**GENOA CHARTER TOWNSHIP
PLANNING COMMISSION PUBLIC HEARING
MARCH 13, 2017
MONDAY
6:30 P.M.
AGENDA**

OPEN PUBLIC HEARING #1...Review of site plan application and impact assessment for a proposed 101 room 4 story “Hampton Inn and Suites” hotel located southwest of the Grand Oaks Drive and Latson Road intersection. The property is located within the Livingston Commons Phase 2 PUD on parcel #11-08-200-020. The request is petitioned by Howell Hospitality Inc.

Attention:	Kelly Van Marter, AICP Planning Director and Assistant Township Manager
Subject:	Hampton Inn & Suites – Site Plan Review #2
Location:	Vacant property southwest of the Grand Oaks Drive and Latson Road intersection
Zoning:	NR-PUD Non-Residential Planned Unit Development District

Re: Hampton Inn – Site Plan Review #2

SOUTH ELEVATION

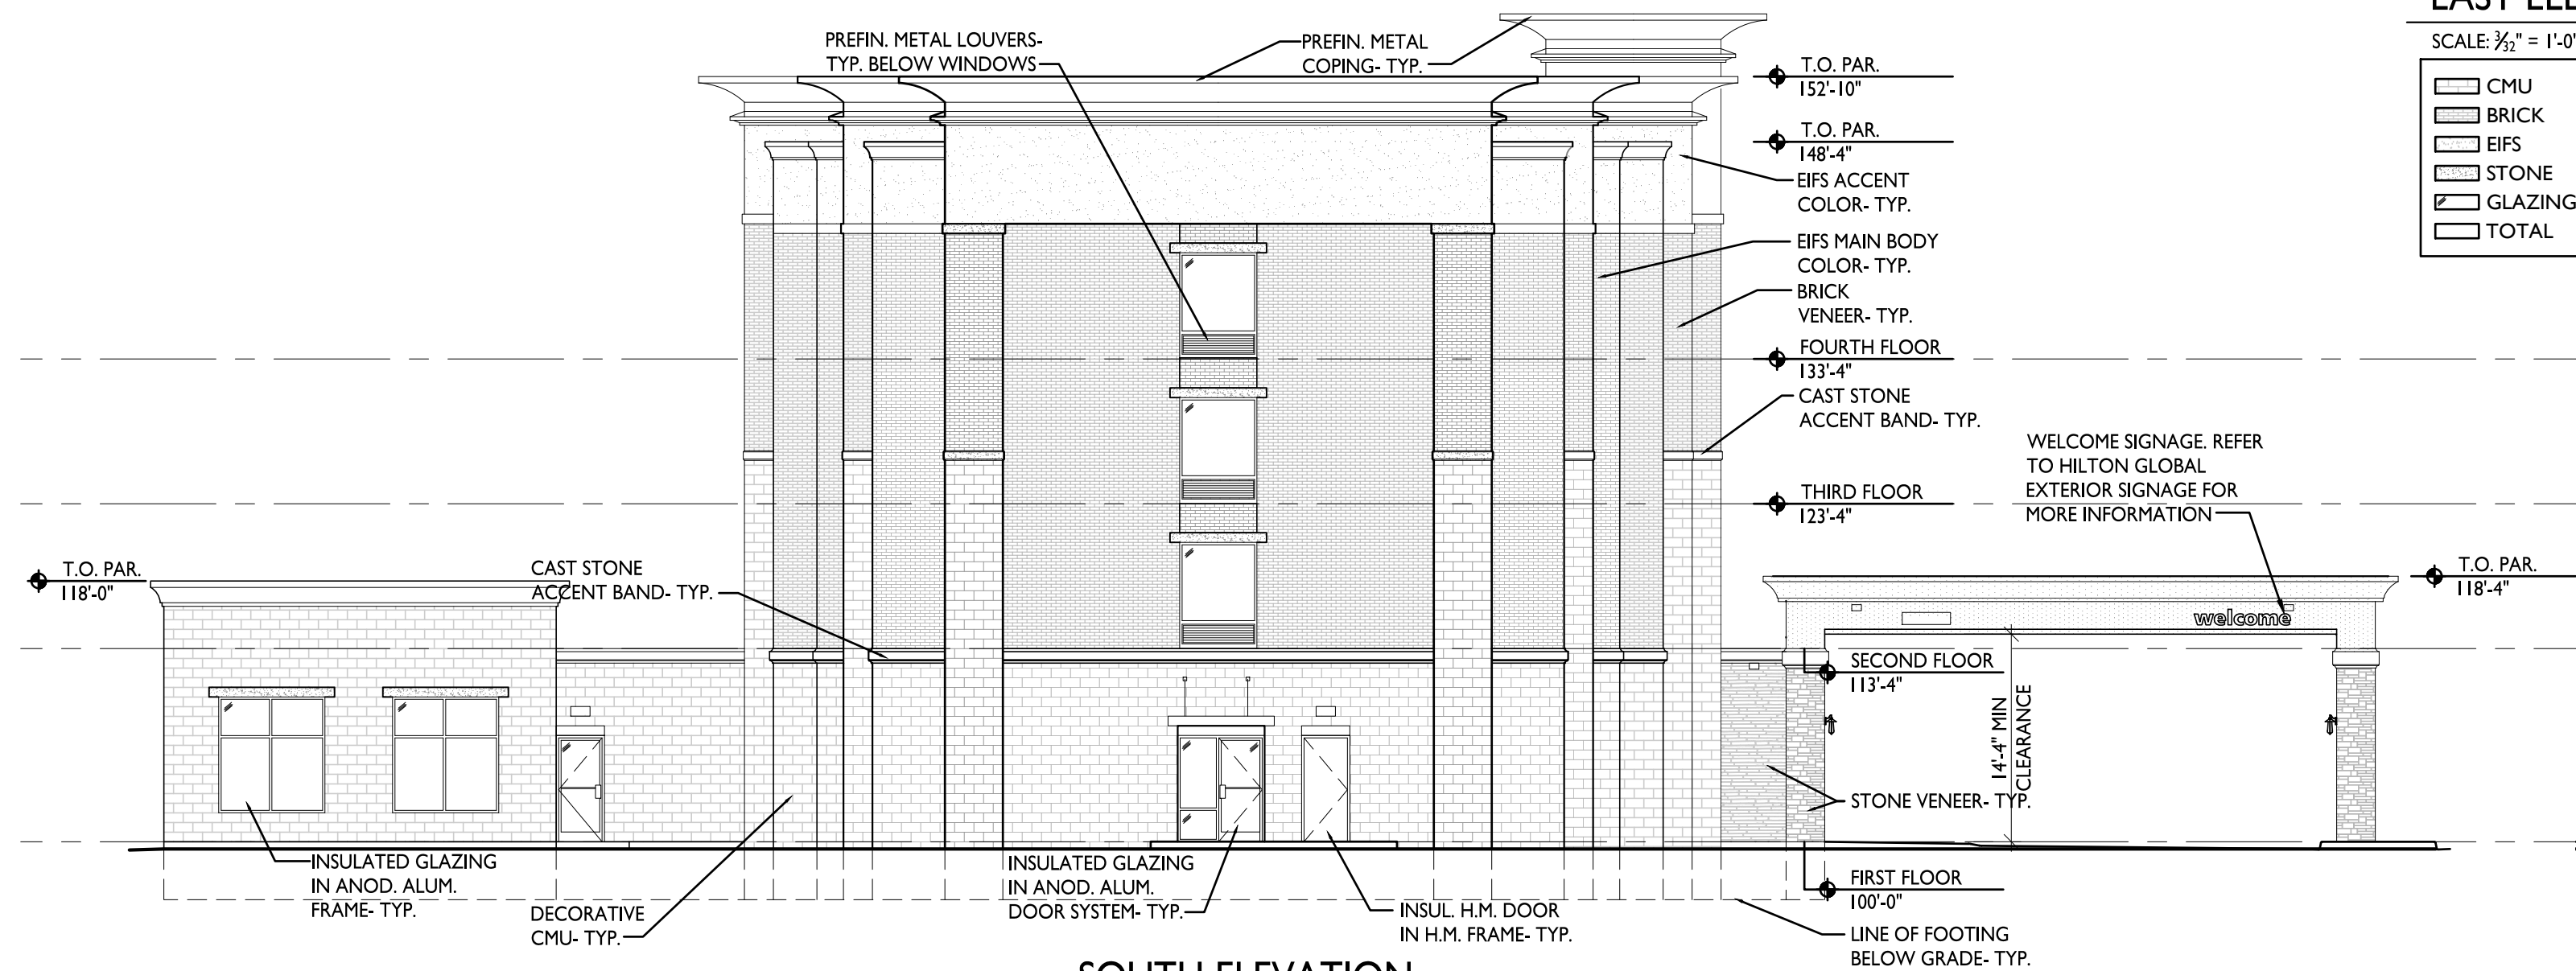
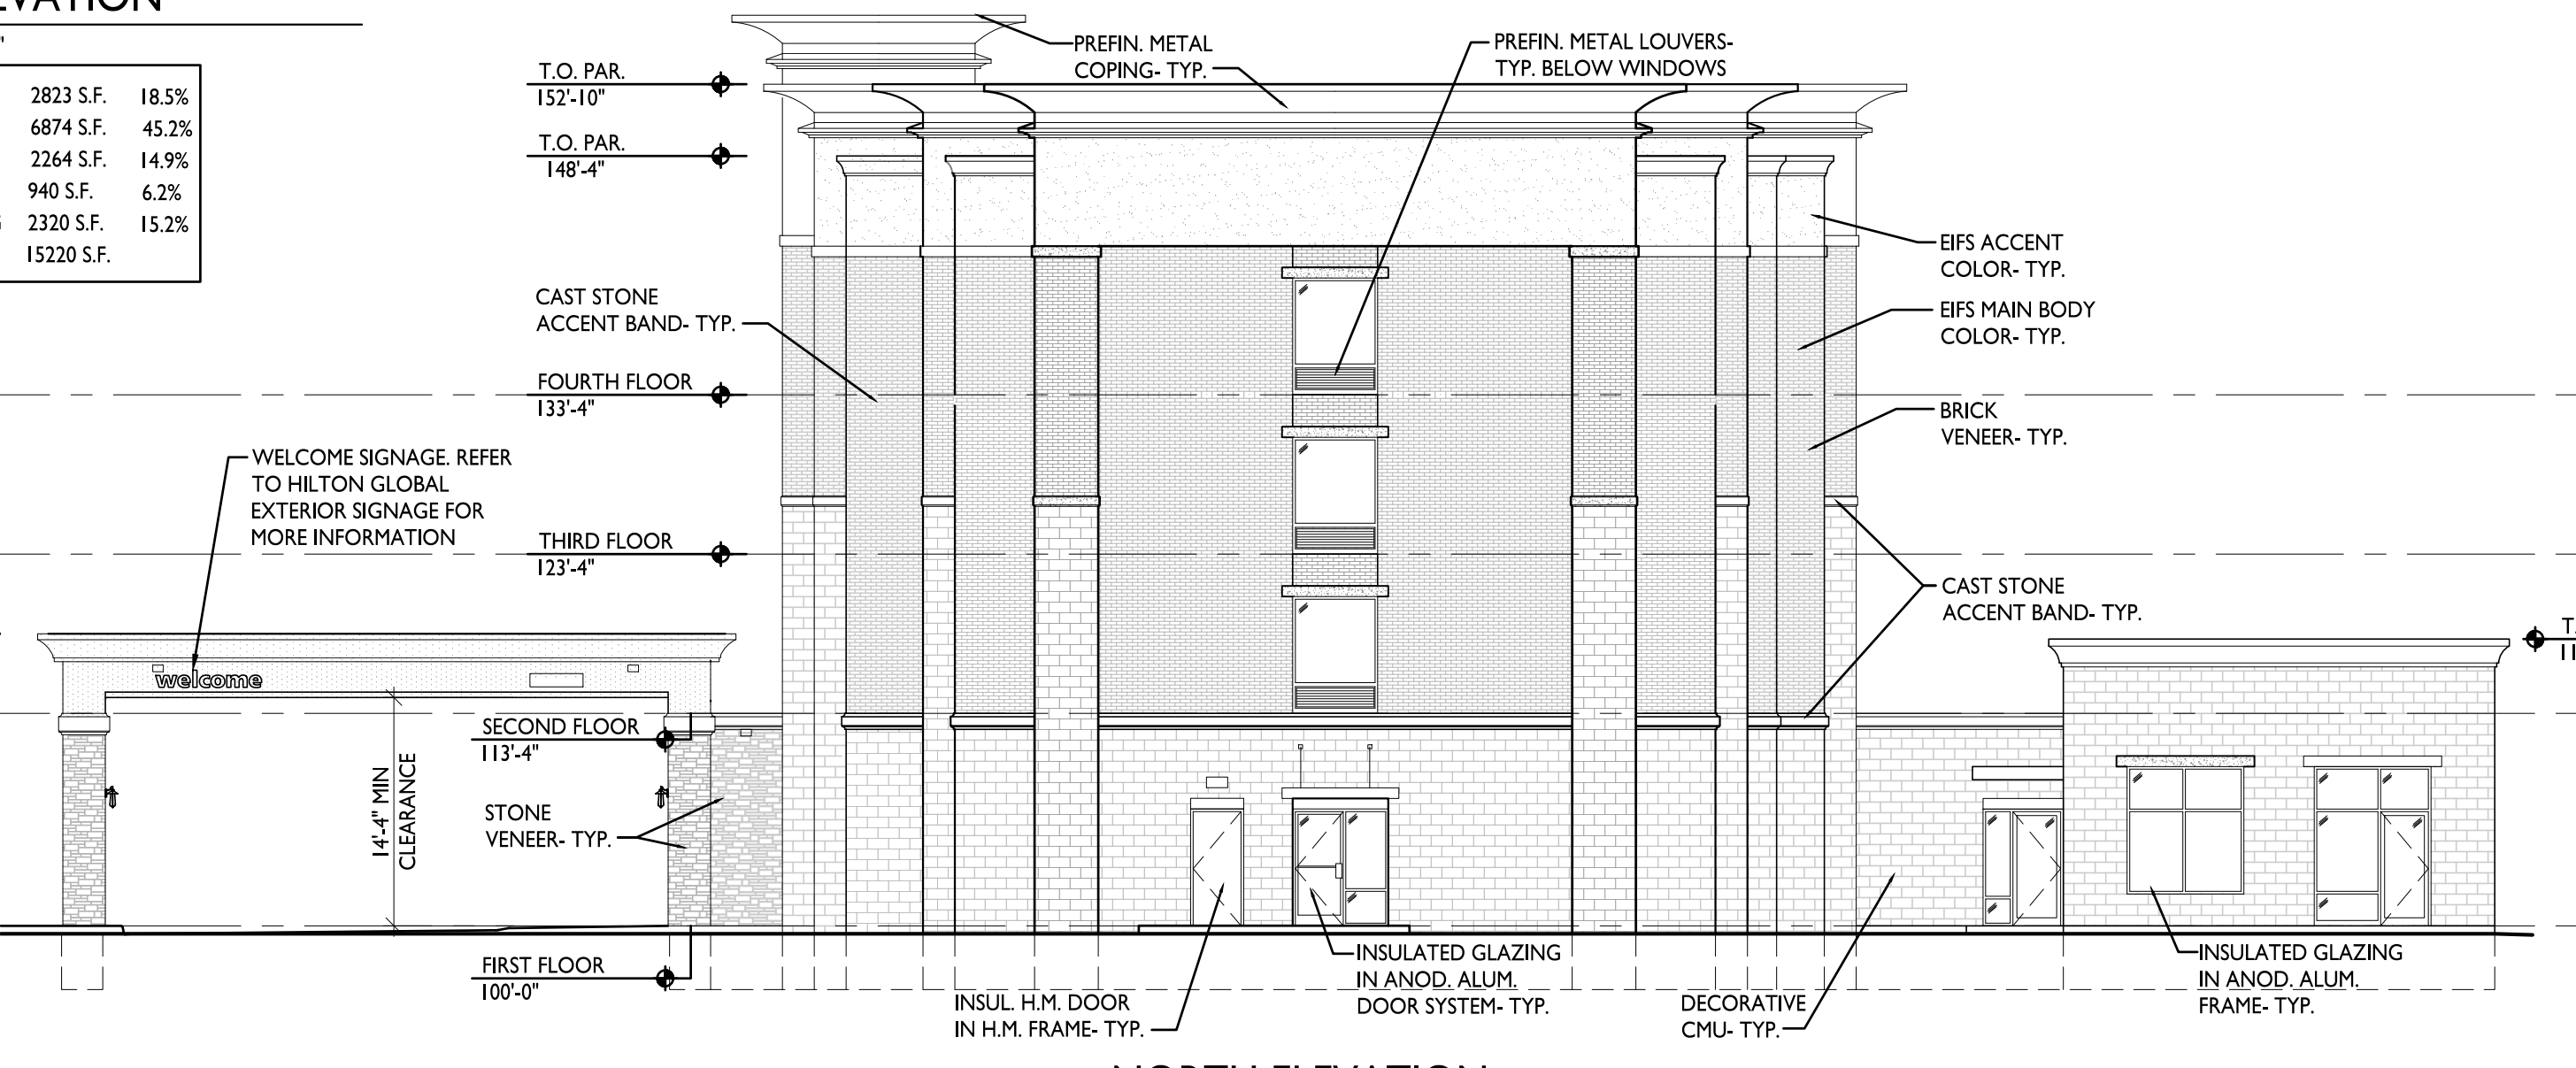
- 2. Building Materials and Design.** The proposed elevations, including colors and materials, are subject to review and approval by the Planning Commission. Building elevation drawings are found on Sheet A5.00. The revised submittal also notes that the applicant will present the Commission with a color rendering and material samples at the upcoming meeting.

The revised drawings include building material calculations demonstrating that the amount of EIFS proposed is compliant; however, we are concerned about the amount of CMU proposed.

The north and south elevations exceed the Ordinance limit of 25% and since it is confined to the first floor, it will be a highly visible element of this building. In our opinion, the proposal would benefit from additional stone that could replace all or part of the CMU.
